Docket Number:	22-AAER-01
Project Title:	Commercial and Industrial Fans and Blowers
TN #:	242893
Document Title:	Joint AMCA-AHRI-NEEA Comments to Proposed Regulatory Language for T20 Fans
Description:	N/A
Filer:	System
Organization:	Joint AMCA-AHRI-NEEA/Michael Ivanovich
Submitter Role:	Public
Submission Date:	4/29/2022 1:14:36 PM
Docketed Date:	4/29/2022

Joint AMCA-AHRI-NEEA Comments to Proposed Regulatory Language for T20 Fans

**Joint Comments to: Title 20. Public Utilities and Energy
Division 2. State Energy Resources Conservation and Development Commission
Chapter 4. Energy Conservation
Article 4. Appliance Efficiency Regulations
Sections 1601 – 1609**

Comment 1606.2

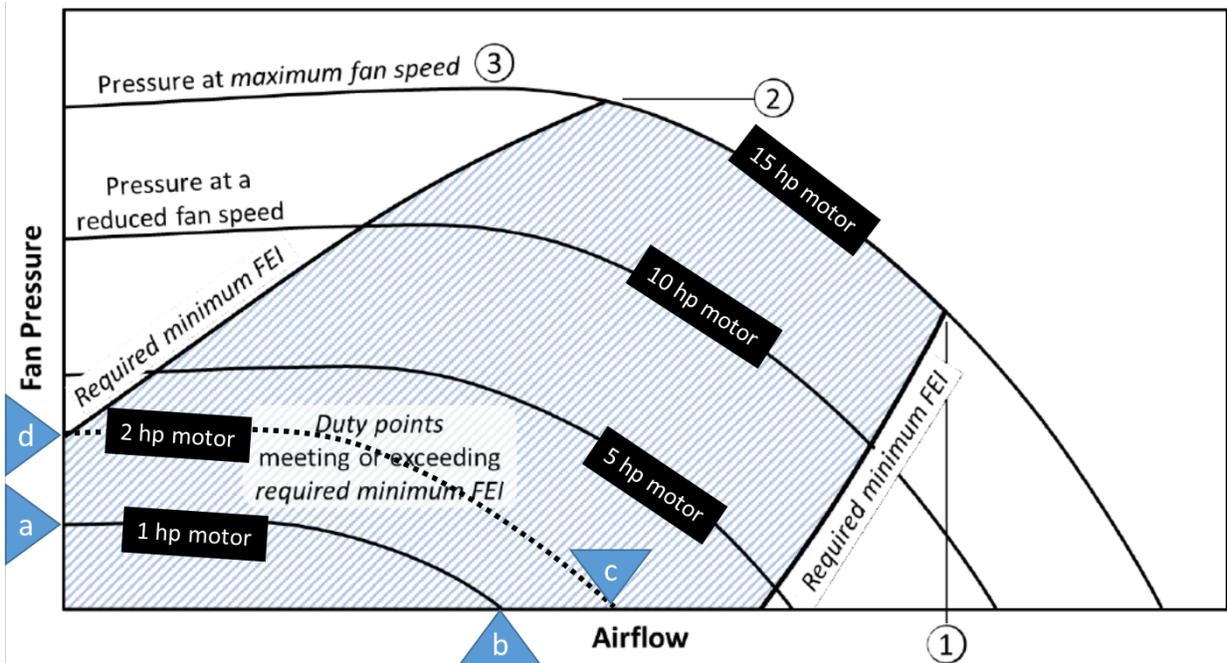
The illustration below is derived from ANSI/AMCA Standard 214-21 Figure H.3. A certain fan is outfitted with motors of five different sizes: 1 hp, 2 hp, 5 hp, 10 hp, and 15 hp.

- All duty points of the fan with the 1-hp motor have an FEI higher than 1.00, even at shutoff (Duty Point a) and wide open (Duty Point b).
- For the fan with the 2-hp motor, only the shutoff Duty Point (d) has an FEI of exactly 1.00.

Definition of duty points with 15 hp motor	
1	Maximum airflow at FEI=1.00
2	Maximum pressure at FEI=1.00
3	Maximum fan speed at FEI≥1.00

Comment 1606.3

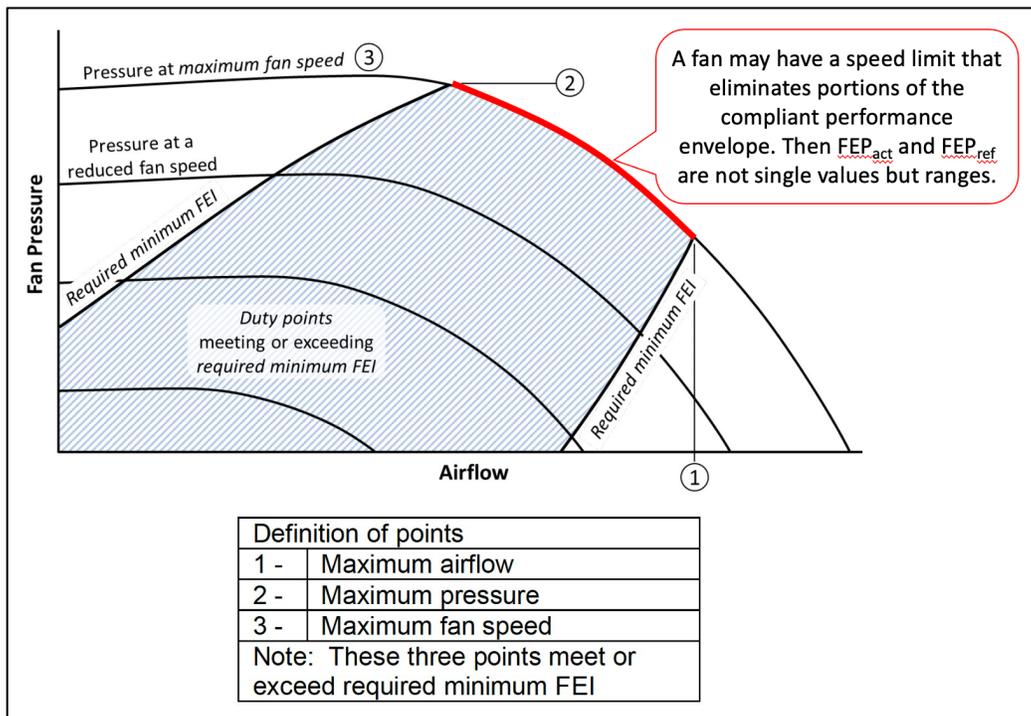
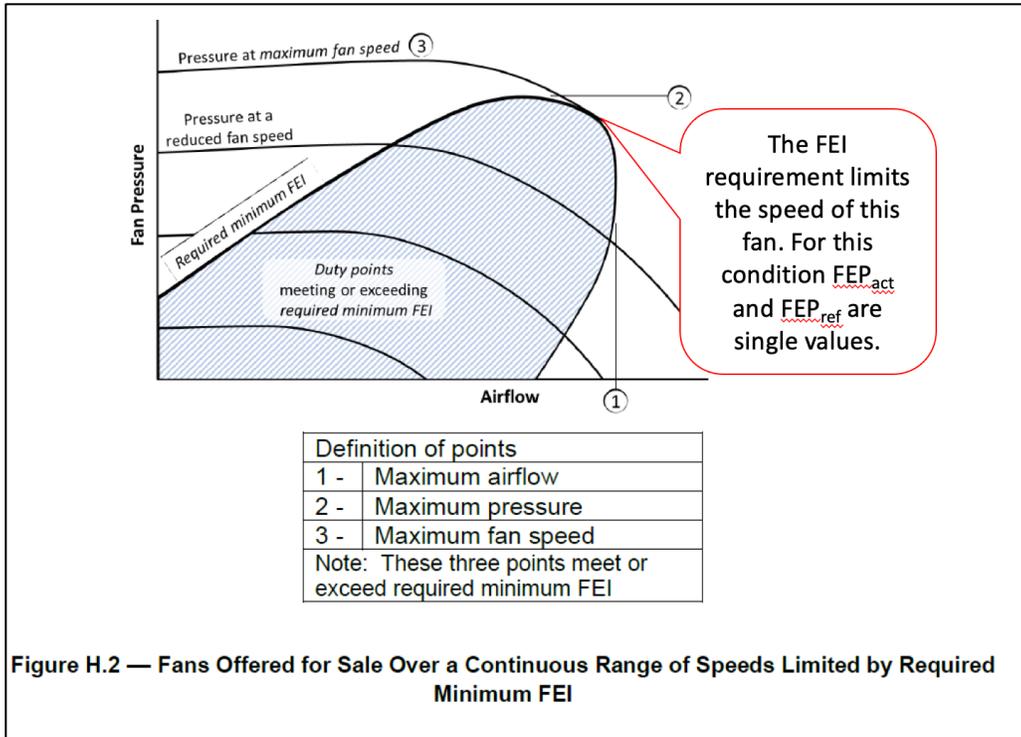
Regarding the removal of FEP_{ref} and FEP_{act} at FEI=1.0 in the table above, the conditions are shown in the figures H.2 and H.4 taken from ANSI/AMCA Standard 214-21 Annex H and marked up below.

Figure H.1 — Fans Offered for Sale Only at Discrete Speeds (example shown has significant variation of speed with load)

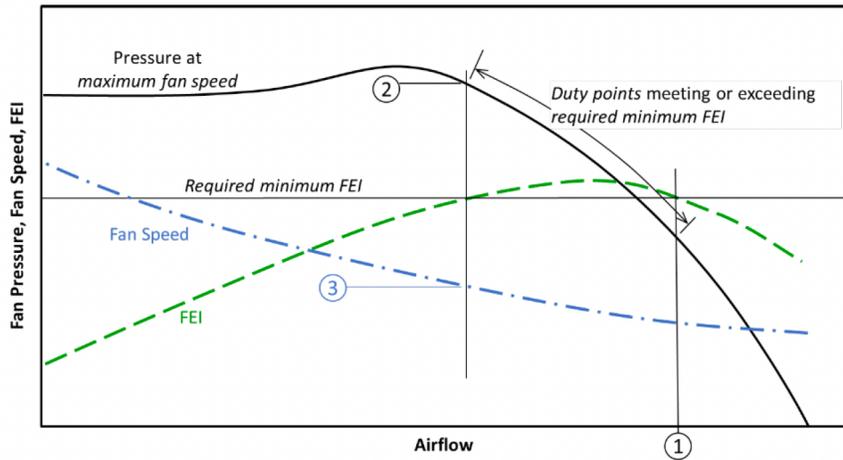
The proposed regulatory language goes much further to prohibit disclosure than it does to distinguish between compliant and non-compliant. The final draft of the staff report did not provide justification for the additional stringency. Because the comments did not anticipate higher-than-recommended stringency, there was little context as to why “distinguishing” would be preferred over “prohibiting.” AMCA, thus, asks that the following rationale be considered toward softening the requirement.

ANSI/AMCA Standard 214 Figure H.1 illustrates performance of a fan which meets the required minimum FEI with only a portion of its fan curve. Depending on the fan model and speed, the portion of the fan curve could be large or it could be small. If the portion is small and the rest of the fan curve is not shown, it is impossible to judge where on the fan curve the portion lies.

An engineer typically expects to see an entire fan curve, even if the fan is offered for sale only in the portion above the required minimum FEI. The ability to see an entire fan curve allows an engineer to answer some important questions about the selection of a fan:

1. What is the maximum pressure the fan develops at shutoff (zero airflow)?
 - Determining the maximum design pressure of a damper.
 - Determining the maximum design pressure of the duct.

2. How close is the design operating point to the stall point?
 - If the installed operating pressure is greater than the design operating pressure, the fan could shift operation into stall, resulting in increased sound, unstable operation, or even catastrophic failure of the fan.
3. What is the maximum power the fan develops at the design speed?
 - Some fan types (forward-curved wheels, radial wheels, high-pitched axial fans) have their peak power at free air (zero pressure), which typically has a low FEI value. Motors often are selected at the maximum power on a fan curve.

Appendix 1.2: Current California Title 20 Proposal

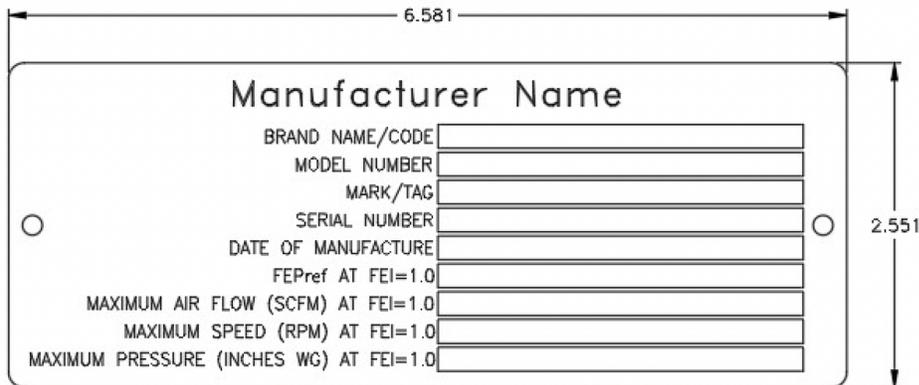
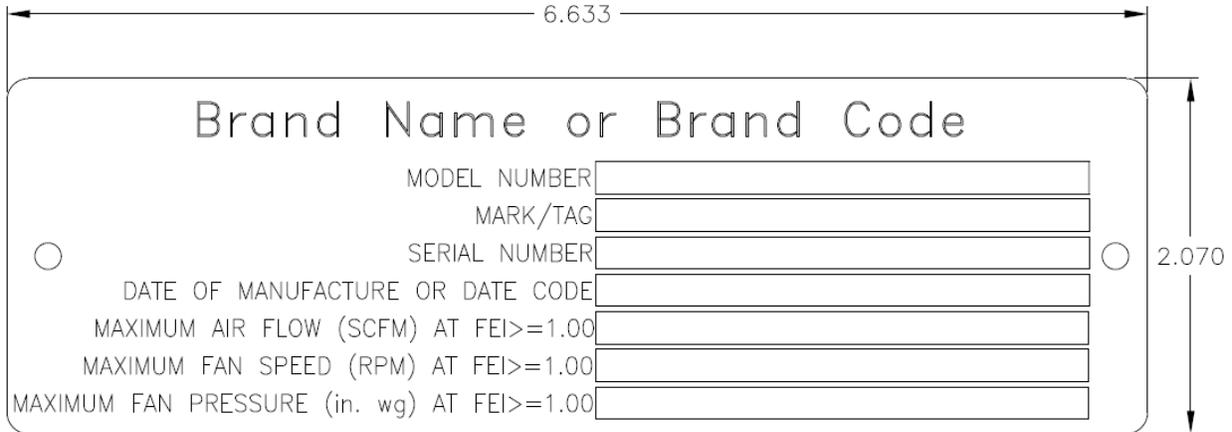
For illustrative purposes, Appendix 1 to these comments shows examples of nameplates currently used in industry practice and compares mockups of the CEC-proposed parameters and AMCA-proposed parameters for a nameplate. Regarding “permanent” labels, AMCA asks: Can manufacturers supplement their standard nameplate (Appendix 1.1) with a sticker with the remaining parameters required by CEC, or must manufacturers have all required marking data on a single metal nameplate or sticker?

The label below is based on labeling requirements in the current proposed draft of California Title 20.

The label below is based on labeling requirements proposed by AMCA members. Date code could be incorporated into the serial-number line.
